UNITED STATES PATENT AND TRADEMARK OFFICE

APPLICATION NO.	FILING DATE	FIRST NAMED INVENTOR	ATTORNEY DOCKET NO.	CONFIRMATION NO.
09/965,679	09/27/2001	Trent M. Molter	PES-0040	2897
23462	7590	06/16/2006	EXAMINER	
CANTOR COLBURN, LLP - PROTON			WILLS, MONIQUE M	
55 GRIFFIN ROAD SOUTH			ART UNIT	
BLOOMFIELD, CT 06002			PAPER NUMBER	
			1745

Office Action Summary

DETAILED ACTION

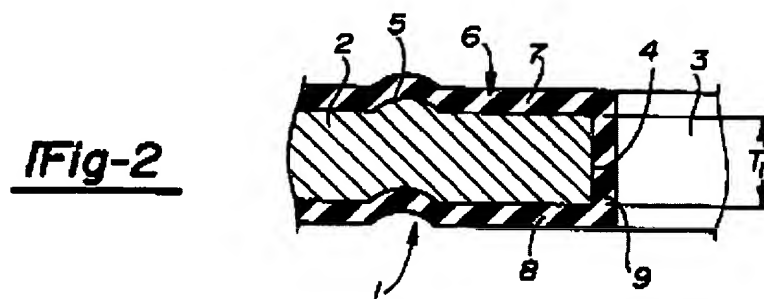
With respect tot claim 56, the ribs and channels are linear and parallel to one another. Specifically, the ribs on one surface, and the channels are on the

opposite surface. With respect to claim 57, the electrically-conductive material is steel (col. 4, lines 35-40). As to claim 60, the elastomeric material is rubber (col. 3, lines 3-40). With respect to claim 63, the electrically conductive material is rectangular in shape. See Figure. 2.
